TECHNICAL BULLETIN

212-11-211
21 March 2011

SUBJECT: NUMBER ONE ENGINE JACKSHAFT SUPPORT INSPECTION AND MODIFICATION OF.

Figure 1

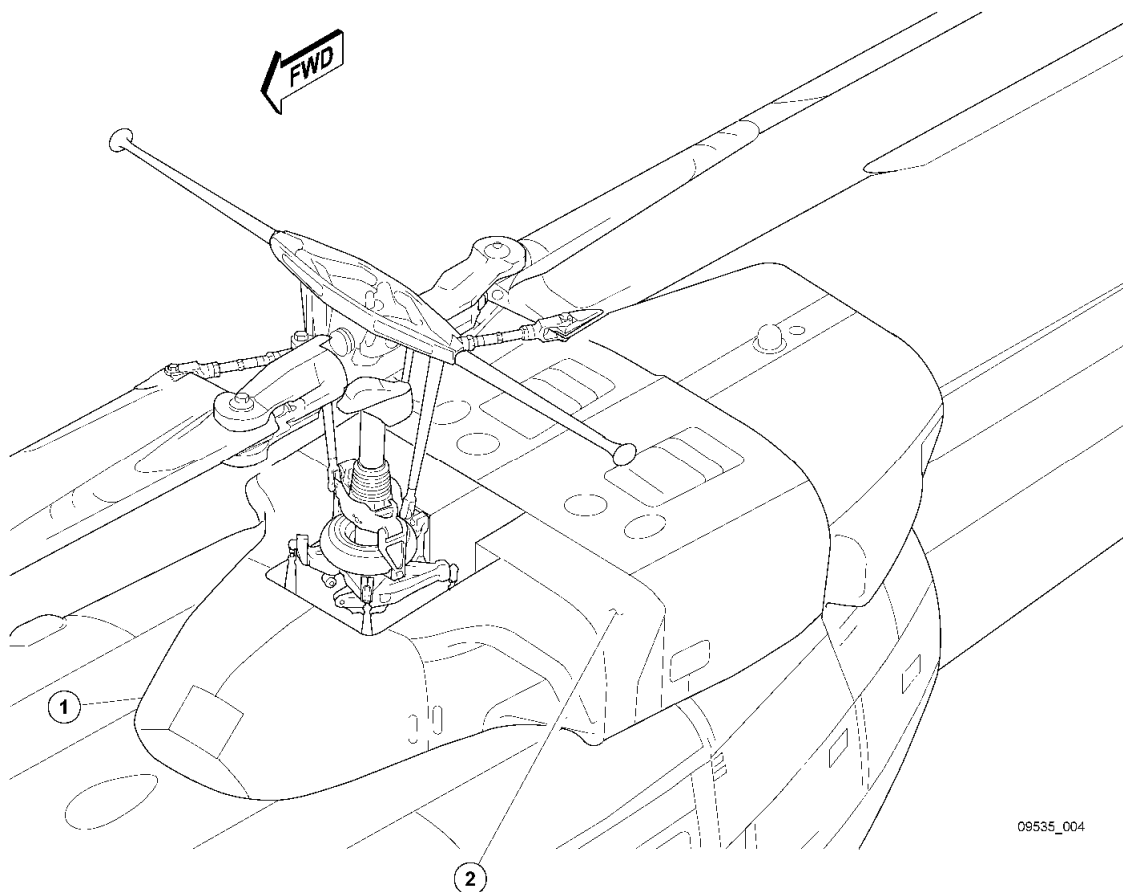
17. Reinstall the left hand air inlet cowling (2, Figure 1) without the transition duct installed and latch in place.
18. With a bright light verify that there is clearance between the N1 jackshaft support and the forward firewall. If the firewall is still contacting the N1 jackshaft support please contact Product Support Engineering.
19. Remove left hand air inlet cowling (2).
20. Reinstall the transition duct (2, Figure 4) on the inlet cowling by installing the two screws (3) and washers (4).
21. Reinstall the left hand air inlet cowling (2, Figure 1) and latch in place.
22. Close and latch transmission cowling (1).
23. Make an entry in helicopter historical service records indicating compliance with Part 2 of this Technical Bulletin.

Figure 2

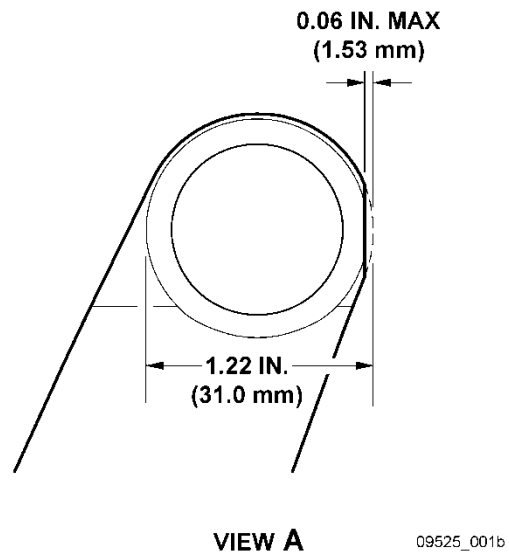
1. Prepare helicopter for maintenance.
2. Open forward transmission cowling (1, Figure 1).
3. Remove left hand air inlet cowling (2).
4. Inspect N1 Jackshaft support bearing boss for wear on the forward side of the boss see Figure 2.

5. Maximum permissible wear on the 1.22" (31.0 mm) Diameter boss is 0.060" (1.53mm) after clean up Figure 2 View A.
6. Blend damaged area including any sharp edges smooth with minimum material removal using 400 grit paper (C- 423).

Figure 3

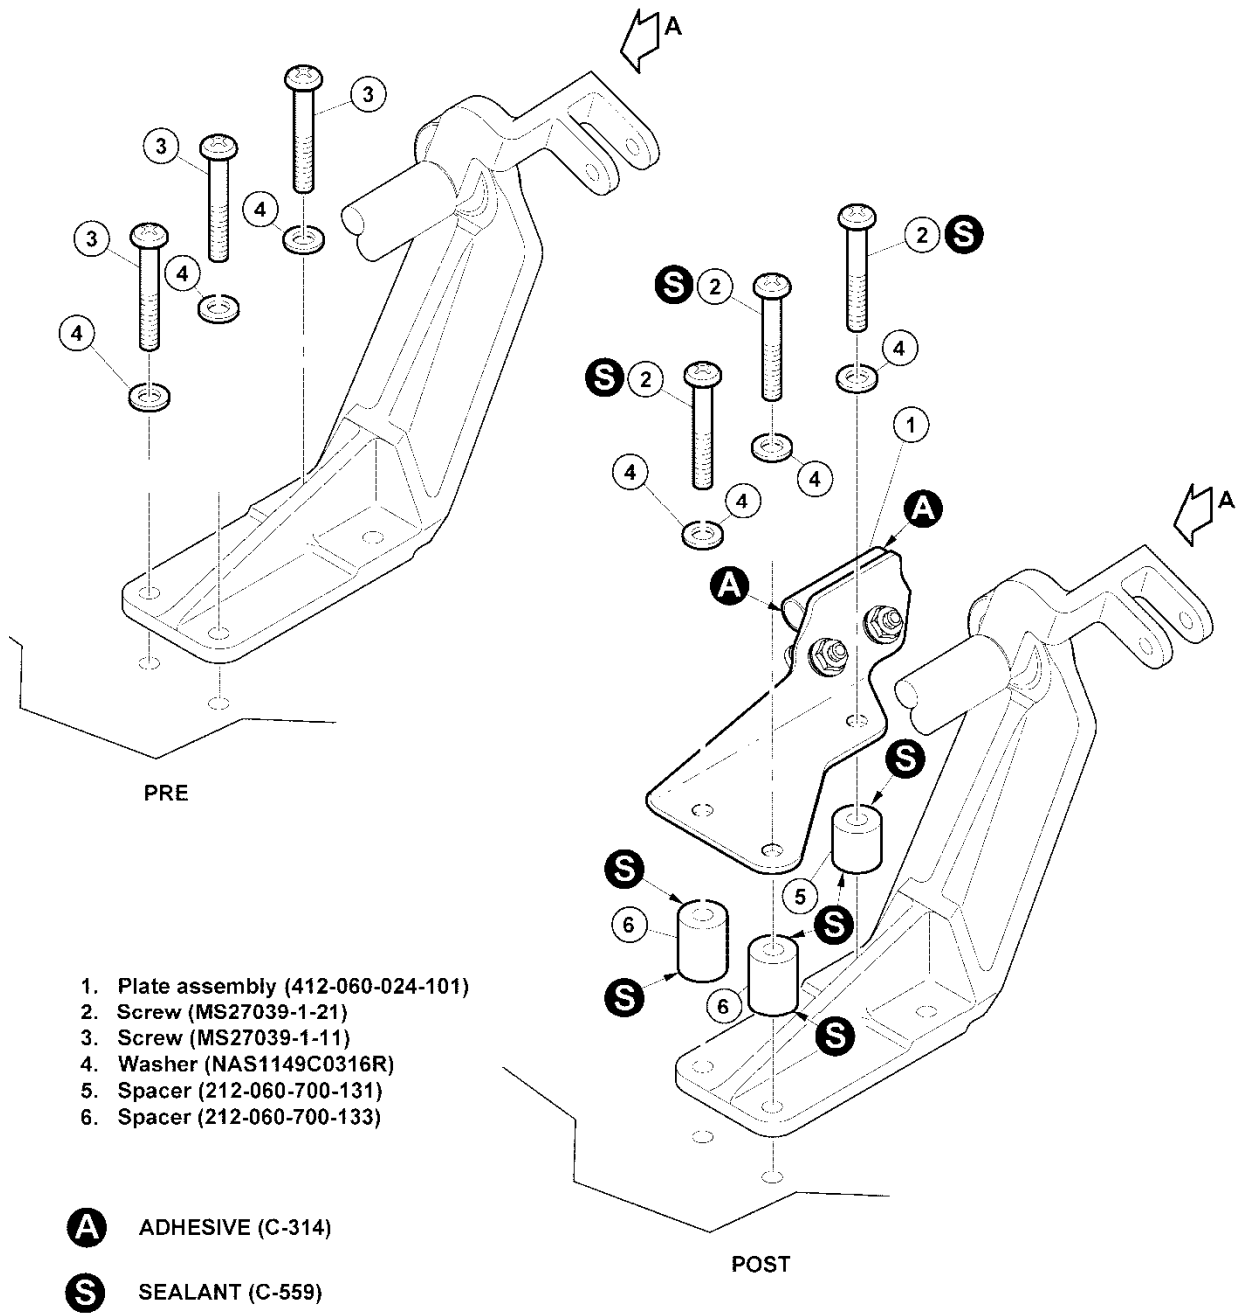
7. Chemical film treat (C-100).
8. Prime repaired surface (C-204).
9. Remove the forward and aft outboard two support retaining screws and the forward inboard support retaining screw (3, Figure 3) and washers (4) from the support and discard.

10. Apply a thin film of sealant (C-599) to the top and bottom of the faying surfaces of the two spacers (6).
11. Apply a thin film of sealant (C-599) to the top and bottom of the faying surfaces of spacer (5).

12. Install the two spacers (6), one on the forward and one on the aft outboard holes on top of the support.
13. Install one spacer (5) on the forward inboard hole on top of the support.

14. Place the Snubber Plate Assembly P/N 412-060-024-101(1) on top of the spacers (5 and 6) as shown in figure 3.
15. Apply sealant (C-599) to the shank only of the three screws (2) and install with washers (4) through the Snubber Assembly (1), spacers (5 and 6), and support. Torque the three screws 20-25 in/lbs.

Figure 4

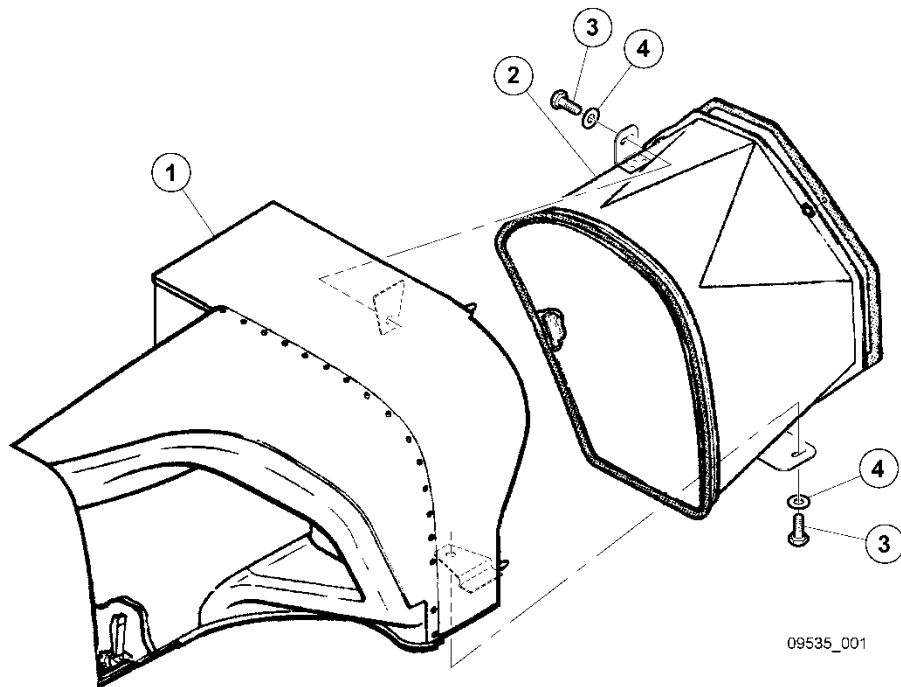
16. Remove the transition duct (2, Figure 4) from the inlet cowling (1) by removing the two screws (3) and washers (4) securing the transition duct to the intake cowling assembly.
